May 02, 2024
Planning Commission
Cases #2023-(7662), (7663) & (7079).
27794 W I-25 Frontage Road
Variances & Development Plan
Bungalows on Cerrillos (Apartments)

EXHIBIT B

Development Review Team (DRT)

Case #2023-7079 - 27794 West I-25 Frontage Road, Bungalows on Cerrillos

5. Improve pedestrian crossing safety by illustrating on the development plan high visibility crosswalk markings on all legs of the Cerrillos/Beckner/Frontage intersection, including slip lanes, and adding a pedestrian refuge island to the southern crossing of Cerrillos.

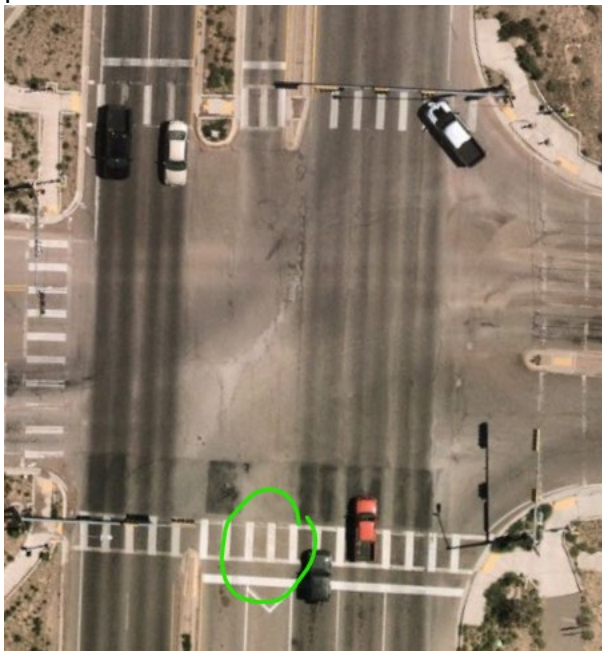
With residential density on the west side of Cerrillos and many destinations on the east side of Cerrillos, ensuring the Cerrillos crossing is safe for pedestrians is critical. High visibility continental crosswalk striping should be added and/or rehabilitated on each side of the Cerrillos and Beckner/Frontage crosswalk.

On the southern crossing on Cerrillos road, there is not a pedestrian refuge island as seen on the northern crossing. A minimum 6ft wide pedestrian island should be demonstrated on the plans.

6. Redesign the right turn slip lanes onto and off of the frontage road to limit speeds to 15mph or less.

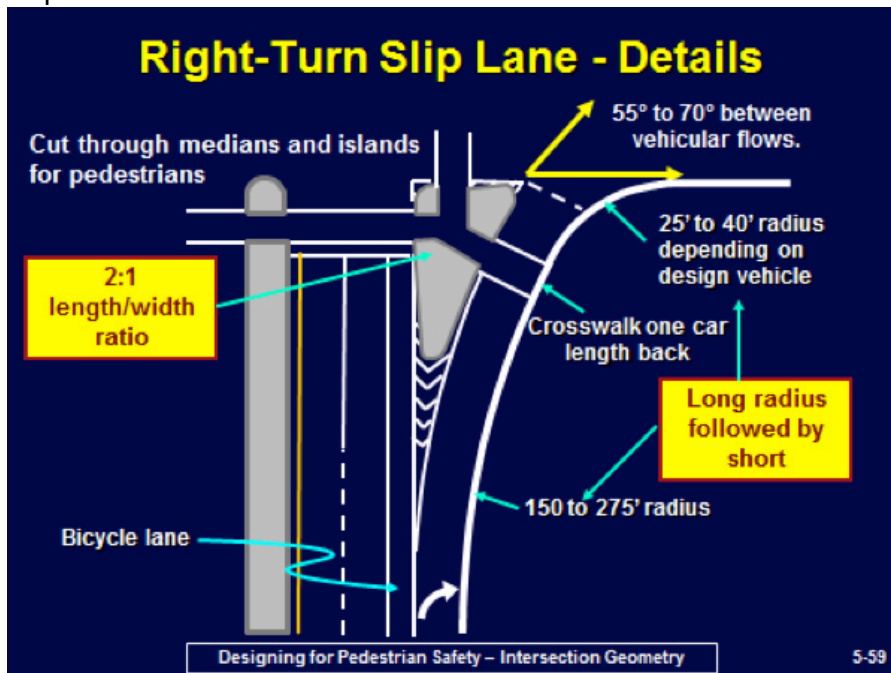
The existing channelized right turn lanes are designed to facilitate high speed right turns. In the existing context without significant bicycle or pedestrian traffic this may be appropriate, however, the addition of a residential community that necessitates residents to use this intersection for all modes of transportation creates a significant safety concern.

NACTO guidelines recommend a turning speed of 15mph or less for pedestrian safety.

The northern turning radius is approximately 140 ft and the southern turning radius is approximately 120 ft. These far exceed the minimum turning radii in the City Code (25ft) and the minimum needed to accommodate large vehicles (35 ft) (14-9.2 (c)(6)(f)). The large turning radii are dangerous for pedestrians because they allow for high speed turning which makes it more difficult for vehicles to stop if there is a pedestrian. Pedestrian likelihood of fatality and severe injury increases exponentially as vehicle speed increases. Additionally, there are not traffic control devices for this crossing relying on drivers to see the pedestrian, and the channelization increases the pedestrian crossing distance.

The right turn channels should be redesigned for safety as shown in FHWA guidance to improve visibility and reduce speeds. This should include narrowing the existing lane to the minimum requirement.
